UNITED STATES  
NUCLEAR REGULATORY COMMISSION  
WASHINGTON, D.C. 20555-0001

September 6, 2016

SUBJECT: TECHNICAL REVIEW: U.S. DEPARTMENT OF ENERGY  
DOCUMENTATION RELATED TO TANKS 16H AND 12H  
GROUTING OPERATIONS WITH EMPHASES ON  
SPECIFICATIONS, TESTING, RECOMMENDATIONS AND  
PLACEMENT PROCEDURES (PROJECT NO. PRO0734)

**Figure 2. A and B. Onlapping Black Bleed Water and Tank Grout Flowing Beneath. Date of Video: June 11, 2016. C. and D. Mottling Evidence of Black Bleed Water after Tank Grout Dried. Date of Video: June 15, 2016.**

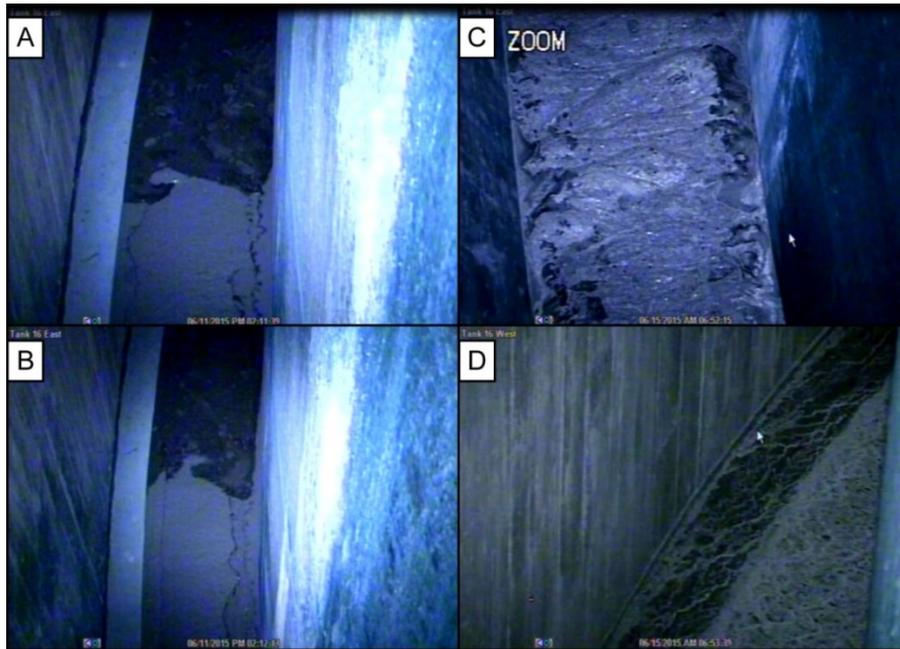
During the July 28–29, 2015, onsite observation tour, NRC staff noted discoloration in the annulus grout, or mottling that may have indicated bleed water segregation (e.g., Figure 2). The camera operator indicated that there were shadows around the edges of flow lobes, but not necessarily cracks; however, he noted that surficial microcracks were sometimes observed on the grout surface (ADAMS Accession No. ML15239A612). During review of Tank 16H annulus-inspection video acquired on the mornings of June 15 and 16, 2015 (SRR-CWDA-2015-00170), NRC staff noted the presence of large-aperture cracks in grout that had been placed beneath the West Riser on June 11, 2015. During the inspections, camera operators seemed interested in viewing the wide-aperture cracks. Many were oriented radially (Figure 3), but one system of cracks was *en echelon* parallel to the inner wall and then rotated to radial (Figure 3B). Cracks were noted on either side of a tremie that had been dropped onto the grout surface on June 11, 2015 (Figure 3A and 3B). Another crack was located beneath and to the side of a pig released on June 11, 2015 (Figure 3C and 3D). During the May 17, 2016, teleconference, DOE indicated that more cracks were observed later, at higher levels in the annulus near the top of the tank, which they attributed to ventilation-induced drying (ADAMS Accession No. ML16167A237). DOE staff indicated that cracks were observed to have developed beneath pour points approximately six times during grouting operations, which they attributed to differential topography associated with mounding. Cracks were also observed in grout in the primary, which DOE attributed to drying (ADAMS Accession No. ML16167A237).

- NRC staff observed via Tank 16H grouting video instances of bleed water segregation. Non-uniformly distributed excess water in the tank and annulus may have a potential impact on hydraulic properties and grout quality. DOE should remove excess ponded water from the tank before, during, and near the end of grouting operations, whenever aqueous ponds are present, to ensure adequate quality grout is placed into tanks and annuli. Alternatively, DOE could provide additional information to support a determination that the quantities of water present in the tanks during grouting do not adversely impact grout performance.

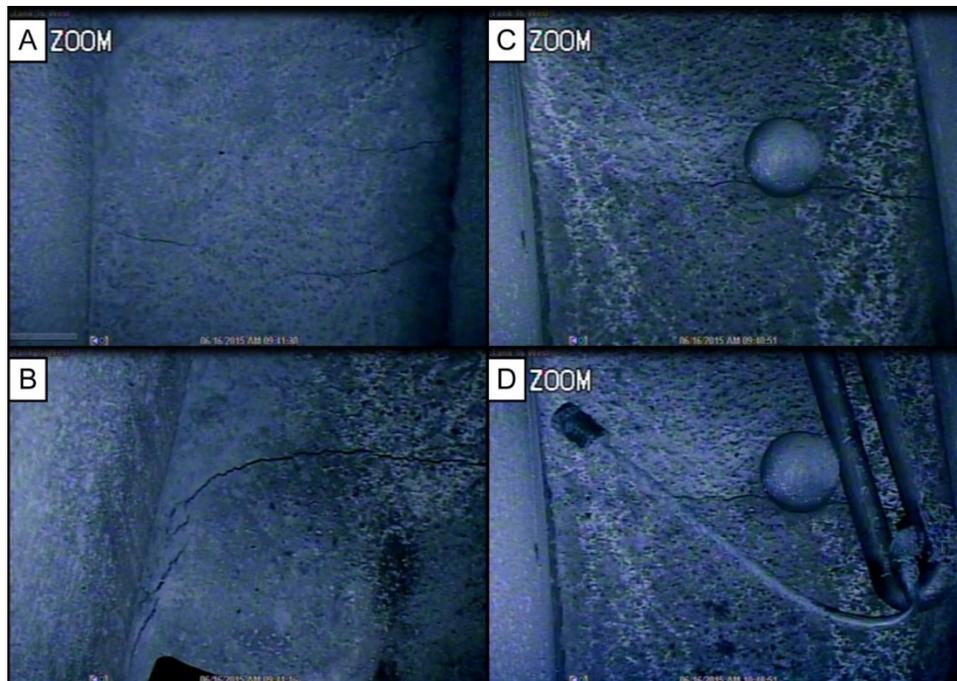
Grout expands during the heating process associated with hydration and then shrinks during cooling, leaving annular shrinkage gaps between the bulk grout mass and other paraphernalia inside tanks and tank annuli, including gaps at walls, around carbon steel cooling coils, equipment, and between adjacent grout flow lobes. Tank grout and clean cap grout are not shrinkage compensating grout mixes. DOE is not planning to develop a shrinkage compensating grout formula due to the low priority they place on this issue and inadequate funding levels (ADAMS Accession No. ML14342A784) and it deleted use of shrinkage-compensating admixtures from Revision 3 of the tank grout procurement specification (C-SPP-F-00055). NRC staff view work to develop shrinkage-compensating grout formulas as potentially important to the adequate closure of tanks. The NRC staff concurs with Stefanko and Langton's (2013) recommendations in SRNL-STI-2011-00551 for testing of shrinkage-compensating admixtures and implementation of measures to help mitigate tank grout shrinkage. DOE should consider giving higher priority to development of a shrinkage compensating grout formula and to its subsequent testing.
